Access Compliance Report

Public Rights-of-Way

(Curb Ramps)

Intersection ID: 10039058	Main Street: SUGAR_HOLLOW_DR	Cross Street: N/A	Location: SW
ADA ID: E2D2D6DD2FDD	Ramp Type: BlendTrans1	Initial Pass/Fail: Fail	Overall Compliance: No
			Severity Score: 33.75

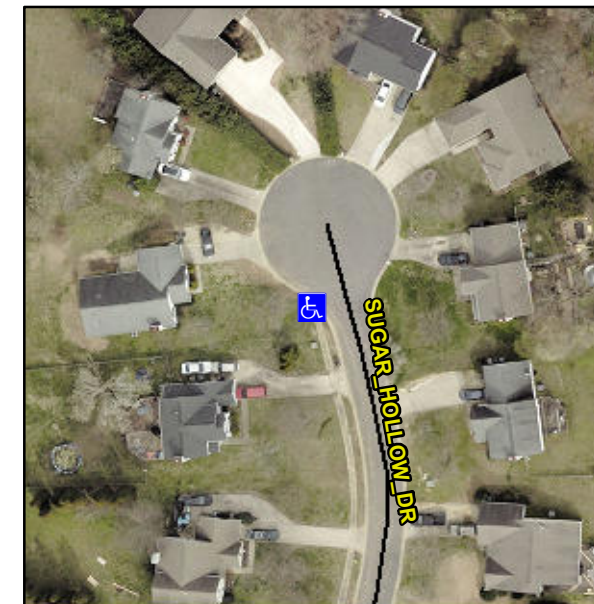
Not Found, R304.5.1, R304.5.3

Compliance	Description	Data	Compliance	Description	Data
N/A	Ramp Length (in)	90.0	Yes	BlendTrans Slope (%)	4.5
No	Ramp Width (in)	36.0	No	BlendTrans XSlope (%)	8.3
N/A	Flare Type LT	N/A	N/A	Flare Type RT	N/A
N/A	Flare Slope LT (%)	N/A	N/A	Flare Slope RT (%)	N/A
N/A	Flare Traversable LT?	N/A	N/A	Flare Traversable RT?	N/A
N/A	Landing Length (in)	N/A	N/A	DWS Provided?	N/A
N/A	Landing Width (in)	N/A	N/A	DWS Contrast?	N/A
N/A	Landing Slope (%)	N/A	N/A	DWS Length (in)	N/A
N/A	Landing X Slope (%)	N/A	N/A	DWS Full Width?	N/A
N/A	Landing Curb? (Y/N)	N/A	N/A	DWS Offset (in)	N/A
N/A	Shared Landing?	N/A			
N/A	Gutter Ponding?	N/A	N/A	Gutter Slope (%)	N/A
N/A	Gutter Lip Ht (in)	N/A	N/A	Gutter X Slope (%)	N/A
N/A	Painted X Walk1?	No	N/A	Painted X Walk2?	N/A
	X Walk 1 Direction	To E		X Walk 2 Direction	N/A
	X Walk 1 Width (in)	N/A		X Walk 2 Width (in)	N/A
	X Walk 1 Slope (%)	9.0		X Walk 2 Slope (%)	N/A
	X Walk 1 X Slope (%)	3.6		X Walk 2 X Slope (%)	N/A

N/A	Ramp inside XWalk1?	N/A	N/A	Ramp inside XWalk2?	N/A
	Road Slope (%)	3.6		Clear Space?	N/A
	Road X Slope (%)	9.0	N/A	Clear Space to XWalk (in)	N/A
N/A	Any Obstructions?	N/A	N/A	Storm Grate/Utility Hazard?	N/A
	Obstruction Type			Storm Grate/Utility Type	
		N/A			N/A
			Yes	Surface Condition? (G/P)	Good
			No	Curb Slope (%)	5.2

Remove & Replace Curb Ramp With Two New Directional Ramps or Equivalent.
